Work Order ID 104861

Item Name: Aft Crosstube

DRAWING NO.
D407-667-245
REV. F
SHEET 1 OF 4
TITLE
CROSSTUBE ASS'Y (407 HIGH AFT)
SCALE
NTS

DRAWING NO. D407-667-245	TITLE CROSSTUBE ASSY (407 HIGH AFT)	REV. F	DART AEROSPACE LTD ENGINEERING ORDER		D.E.O. NO. D407-667-245-F-1	SHEET NO. SHEET 1 OF 2	SCALE NTS
DRAWN [Signature]	CHECKED [Signature]	MFG. APPR. [Signature]	APPROVED [Signature]		DE APPR. [Signature]		
DATE 11.04.08	DATE 11.04.12	DATE 11.04.12	DATE 11.04.12		DATE 11.04.12

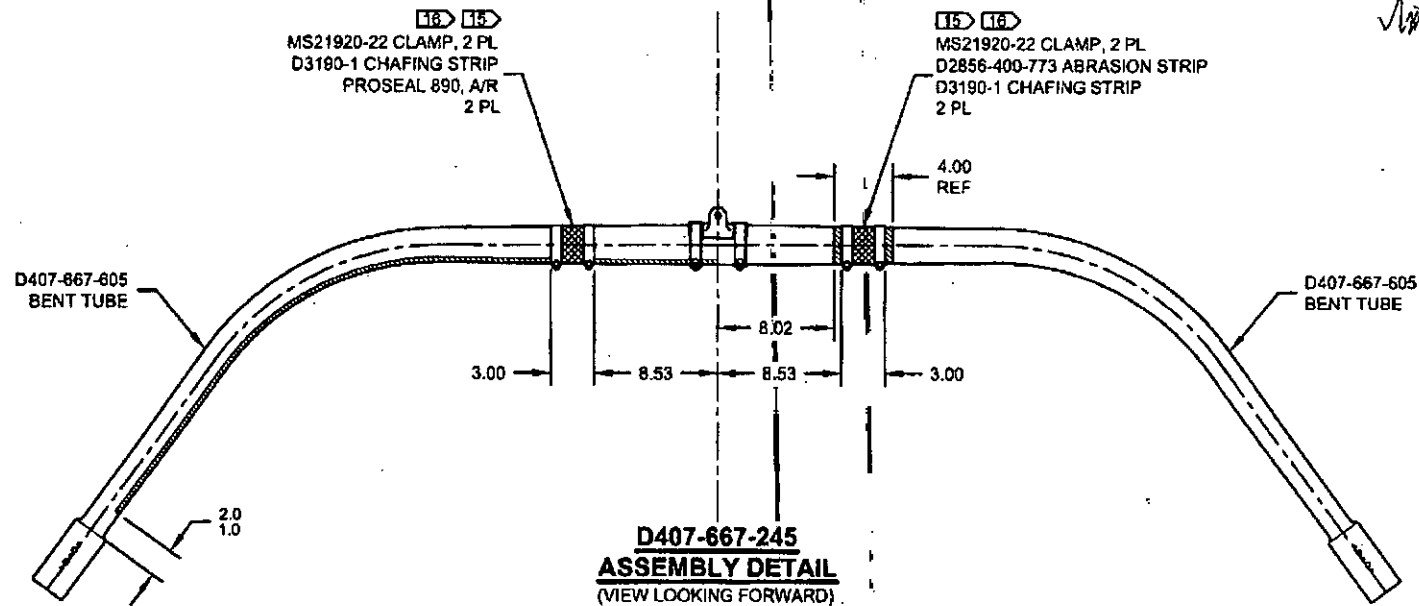
NOTES 2 AND 15, SHEET 1 ARE AMENDED AS FOLLOWS:

- 2) FINISH: CHEMICAL CONVERSION COAT PER DART QSI 005 4.1
PRIME INSIDE AND OUTSIDE PER DART QSI 005 4.2
MASK UNDERSIDE OF CROSSTUBE AS SHOWN (HATCHED AREA) AND
PAINT OUTSIDE PER DART QSI 005 4.2
REMOVE MASKING AND APPLY CLEAR COAT
- 15) APPLY A THIN COAT OF PROSEAL 890 ON INSIDE CONCAVE SURFACE OF D3190-1
CHAFING SHIELDS AND LET CURE PER MANUFACTURER'S INSTRUCTIONS. INSTALL
PROSEAL D3190-1 CHAFING SHIELDS ONTO CROSSTUBE BY APPLYING A THIN COAT
OF PROSEAL 890 ONTO CROSSTUBE. BE SURE TO ELIMINATE ANY AIR GAPS.

MASK AREA PRIOR TO PAINTING.
REMOVE MASKING AFTER PAINT
AND APPLY CLEAR COAT

IS:
